Access Compliance Report

Public Rights-of-Way

(Curb Ramps)

Intersection ID: 51371	Main Street: UNIVERSITY_POINTE_BV	Cross Street: N_TRYON_ST	Location: S
ADA ID: B007BE93B448	Ramp Type: BlendTrans2	Initial Pass/Fail: Pass	Overall Compliance: No
Severity Score: 5			
Codes/Mitigation Info/Possible Solution		Field Measurements/Component Compliance

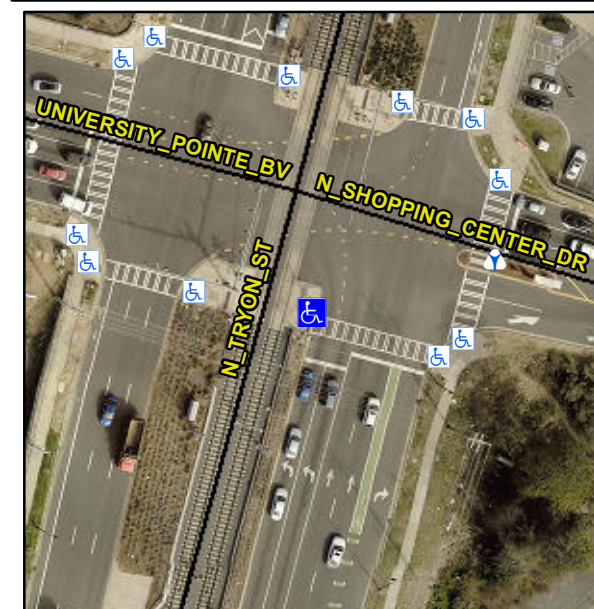
Remove & Replace Curbed Edge.

R304.2.3
